500 TYPE TELEPHONE SETS

1.01 This Supplementary Addendum, which supplements Section C32.535, issue 2 and Addendum, issue C is issued to provide temporary information on several new 500 series telephone sets which are available. This Supplementary Addendum should be retained with subsequent issues of the section until notice is given covering its cancellation or reissue.

1.02 Paragraphs 1.05, 2.19, 2.20, 2.21 and 2.22 and Figures 3, 4 and 5 are added.

Figure 3

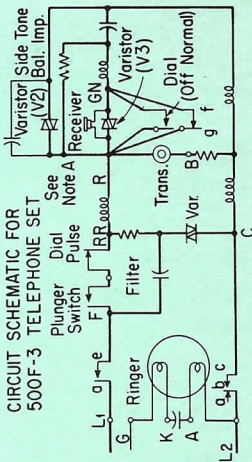
2.19 The 500E-3 (manual) and 500F-3 (dial) sets will replace 302AA and AC sets respectively. These sets are equipped with a left-hand plunger switch to minimize interference, when the hand set is removed at one of the stations on the line when the line is already in use. When the hand set is first removed a low loss a-c bridge, including the receiver and dial filter, is placed across the line. If the line is not already in use, the subscriber pulls up the plunger switch which closes the talking and dialing circuits. Since demands for 302AA (manual) telephone sets have been at levels which do not appear sufficient to warrant the manufacture of comparable 500E-3 (manual) sets,

500E-3 & 500F-3 TELEPHONE SET

WIRING DIAGRAM

- A. 500E-3 (For Manual Service) same as 500F-3 except replace dial with apparatus blank and strap terminal on plunger switch to (RR) terminal on network with black lead as shown.

- B. When the handset is removed, contact, gf, breaks last.

Figure 4

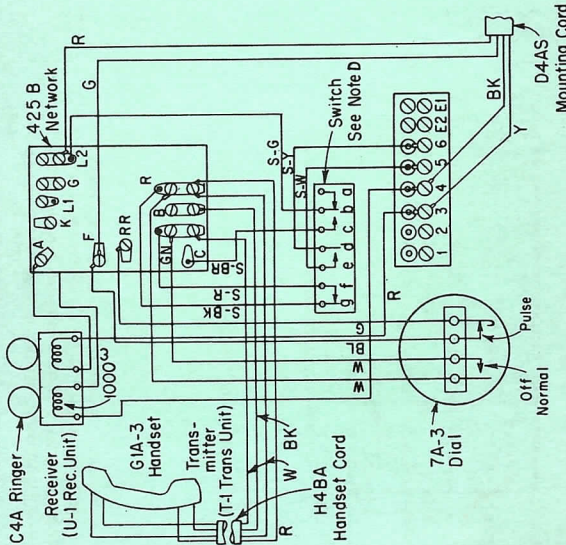
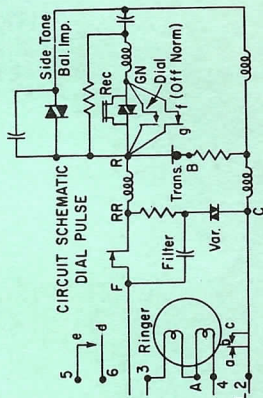
2.20 The 500L-3 (manual) and 500M-3 (dial) telephone sets do not replace any apparatus. These sets are similar to the 500C-3 and 500D-3 telephone sets except for an added terminal strip and a different switchhook circuit arrangement. These changes provide for separate talking and ringing circuits for use with 1A Telephone Answering Sets, 2B Key Telephone Systems and 507A and 507B P.B.X. attendant stations. They also permit the use of additional ringing bridges in specific instances when needed where a local ringing source is available. The 500L-3 (manual) set will be obtainable only by conversion.

500 M-3 TELEPHONE SET

WIRING DIAGRAM FOR 500 M-3 TELEPHONE SET

A. For manual service: (500 L-3) same as 500 M-3 except replace dial with apparatus blank and transfer green lead from (F) to (RR) terminal on network.

B. When ringer condenser is required in series with ringer, transfer slate ringer lead to (K) terminal on network.

C. Contact sequence:

Removing handset- 1. de closes before cb
2. fg opens

Restoring handset- 1. fg closes
2. cb opens before de
